CITY OF YPSILANTI
Agenda
Historic District Commission
Tuesday, June 26, 2018 - 7:00 p.m.
City Hall, Council Chambers, 1 S. Huron
Ypsilanti, MI 48197

HDC Work Permit Staff Review

Property address: 113 Buffalo

Proposed work: side and rear porch installation

PROJECT:
BEAL RESIDENCE
113 BUFFALO ST
YPSILANTI, MI

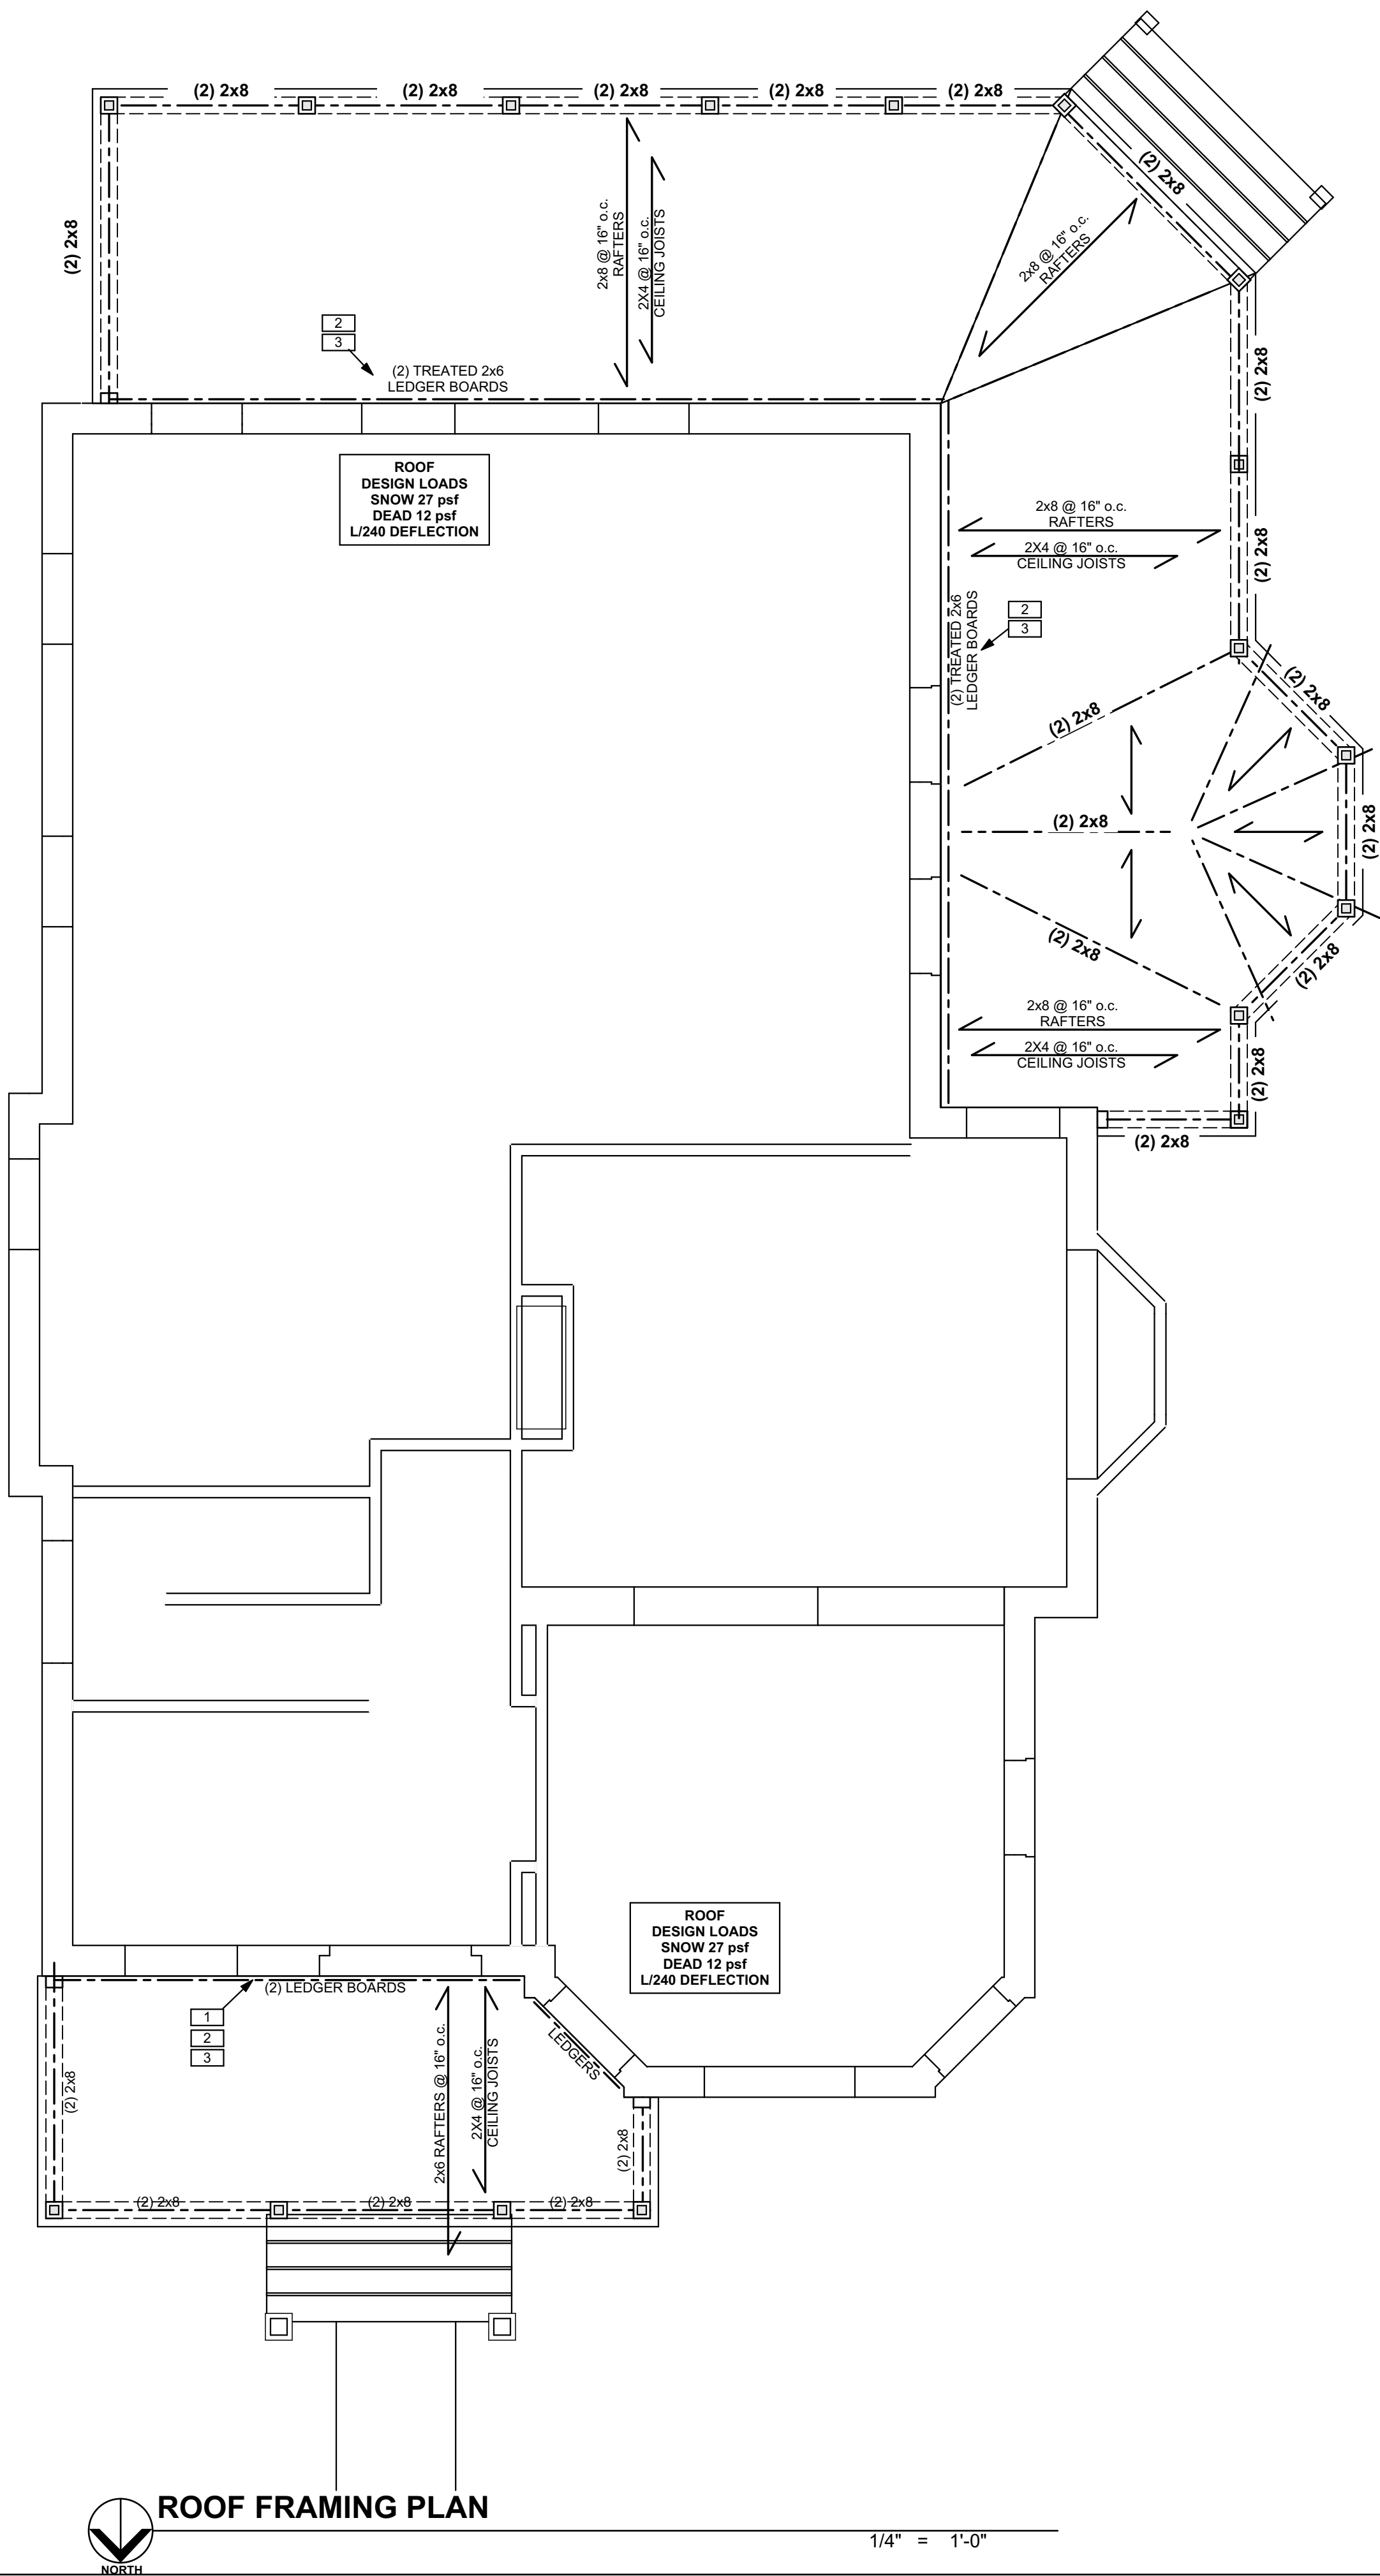
1. The applicant was tabled at the past 2 HDC meetings for a more simplified plan for the porch. The applicant has provided new plans and renderings dated June 21, 2018.

2. The applicant is looking to install a side/rear wraparound porch on the southwest side of the house, a recessed hot tub will be installed as well.
3. Changes from the originally submitted design include changes to the lattice in the skirting area, the removal of the spindles in the header area, and less details on the posts.

4. The applicant was previously approved by the HDC for the front porch rehab on September 27, 2016.
5. The applicant has included three historic photos for documentation; however this is a new porch and the historic side porch does not appear to have been a wraparound porch thus it should be differentiated from the historic style.

6. The applicant plans to use beadboard for the porch ceiling, Tamko 3-tab shingles for roofing to match the house, tongue & grove fir decking, lattice to match the plans, concrete footings, wood joists, rafters and lintels.

7. HDC to verify that the main material for the porch is wood and that all wood parts are to be fir or similar.

8. What appears to be k-style gutters are indicated on the plans. HDC to verify this and what color the gutters will be.
9. HDC to confirm the location and if there will be any additional structure above ground for the hot tub.
10. Painting on the porch will be in the following to match the house: Valspar Sequoia Glade (main), La Fonda Mirage (accent), Cincinnati Hotel Nichols Taupe (second trim)
11. A Zoning review will be required.
12. A building department permit will be required for this work and should be obtained prior to the start of any work.

Move to approve the application for work on 113 Buffalo St to include the installation of a wood side and rear wraparound porch as depicted in the architect plans and renderings dated June 21, 2018. Work to include the installation of fir porch decking, a bead board porch ceiling, and concrete footings with Tamko 3-tab shingles on the roof to match the main house. The porch is to be painted in the existing color scheme of the house: the main color is Valspar Sequoia Glade, the accent color is La Fonda Mirage and the second trim color is to be Cincinnati Hotel Nichols Taupe. K- Style gutters will be installed and painted to match the color scheme. A hot tub will be recessed into the ground at the southeast corner of the rear portion of the porch.
